TENNESSEE VALLEY AUTHORITY

*HRB
Kingston -
Ash Disposal*

SUBJECT: KINGSTON STEAM PLANT - ANNUAL ASH DISPOSAL AREA INSPECTION

SUBJECT: KINGSTON STEAM PLANT - ANNUAL ASH DISPOSAL AREA INSPECTION

④

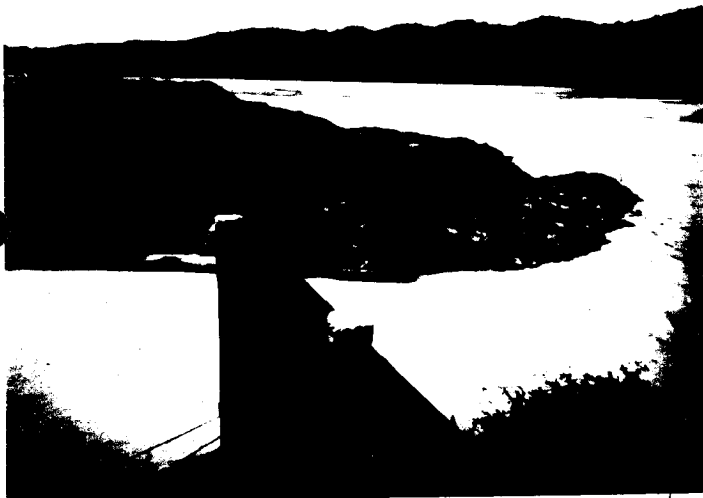
The two buoyant skimmers in the divider dike flow-through spillway appear to be functioning properly with minimal loss of ash into the stilling pool area (picture 4). However, a fly ash slurry was observed covering at least 50 percent or more of the stilling pool area surface (picture 8).

7. The channel bottom has been lowered and two longer buoyant skimmers have been placed in the flow-through spillway (picture 4). These skimmers appear to be functioning properly.

Looking into stilling pool area from divider dike. Note fly ash slurry on water surface in front of floating skimmer.

⑨

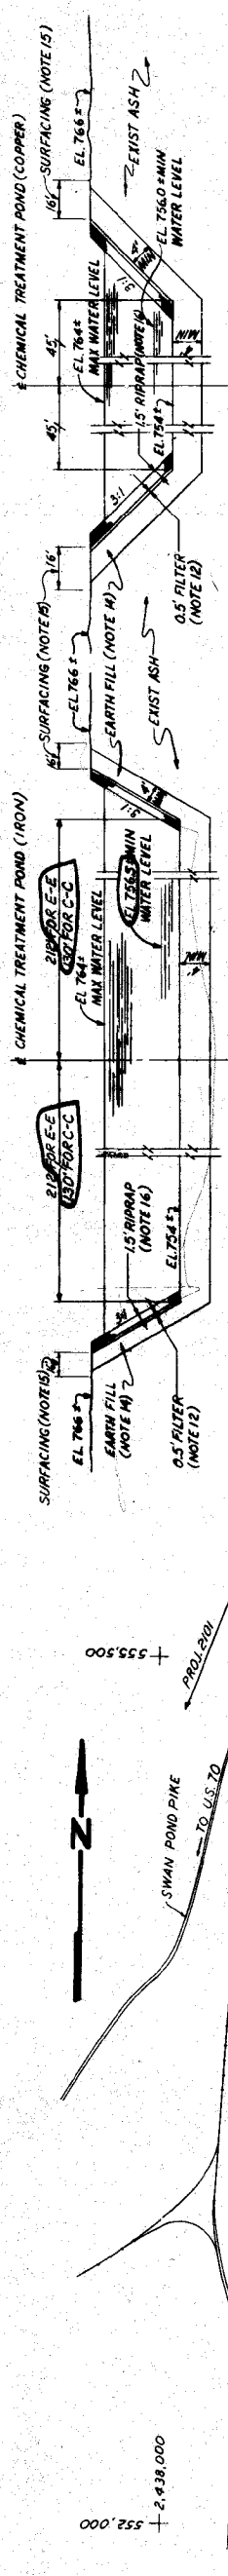
Some areas of the dike slopes, both interior and exterior, have an excellent vegetative cover (pictures 2 and 3); while other areas have a very sparse vegetative cover or are completely bare (pictures 6, 7, and 9 and recommendation 2). Small erosion gullies have developed in parts of the bare areas.

Looking into standard spillway outlets. Note absence of vegetative cover on dike slope above spillway outlets.

1. Plant personnel should regrade the area of surface wetness at the south end of dike C (picture 1) so that surface runoff is not concentrated at the toe of the dike slope and will flow into Watts Bar Reservoir. This area should then be observed for a period of time to determine if a seepage problem exists.
2. Fertilize and reseed all areas of the dike slopes where an adequate vegetative cover has not been established with type 6, mixture E, in accordance with sections 180 and 182 of the T-1 Specifications.
3. Repair any earthfill dike slope erosion that may occur prior to the establishment of an adequate vegetative cover.
4. Repair badly eroded areas of the divider dike slopes.

PLAN-RAISING ASH DISPOSAL AREA DIKE

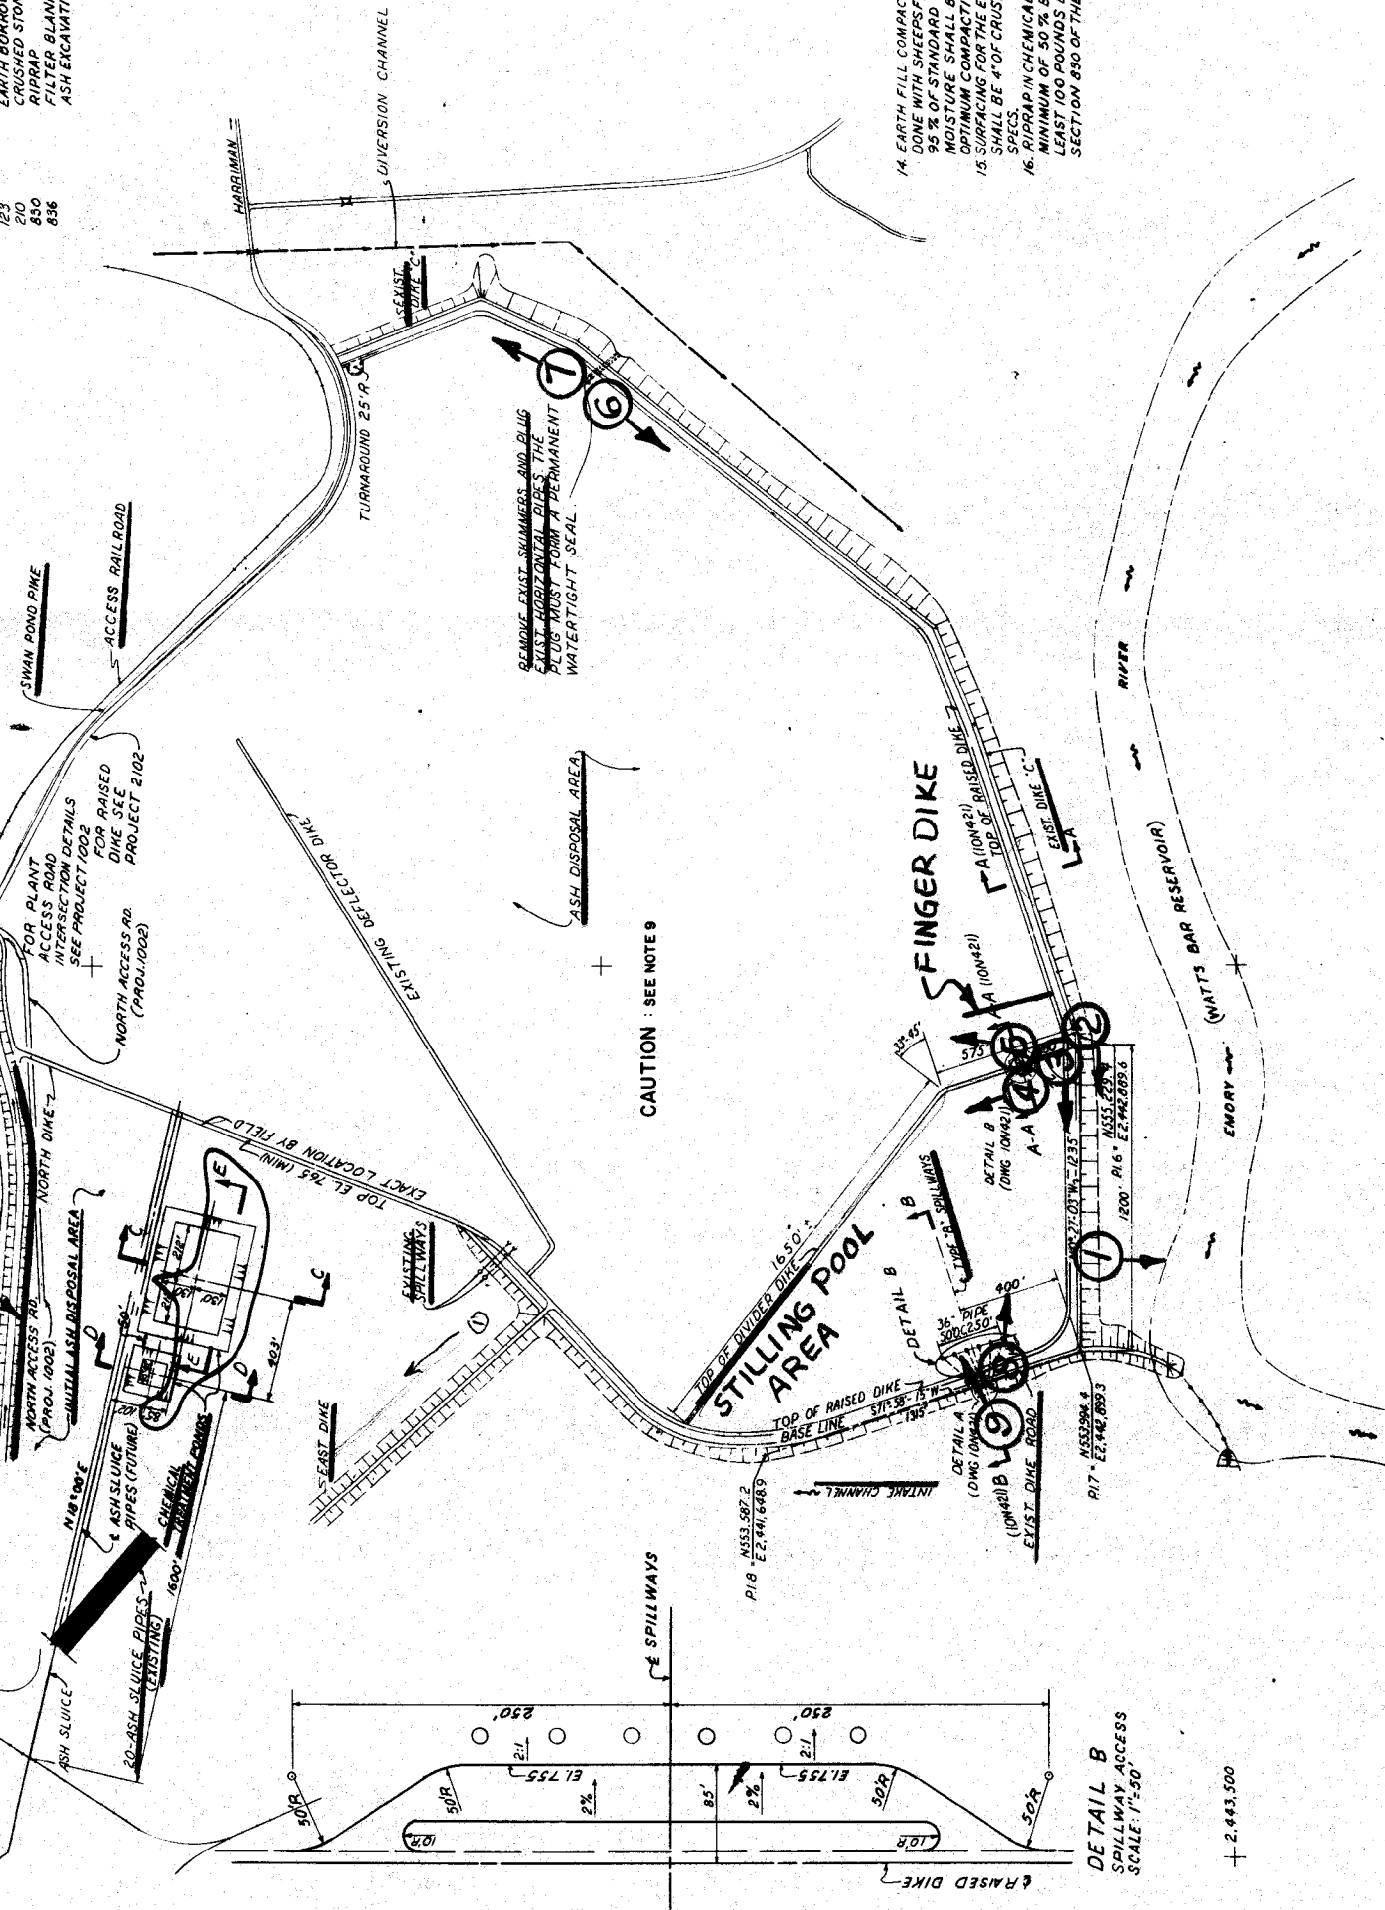
On the attached print of drawing 10N420, the different areas are designated.
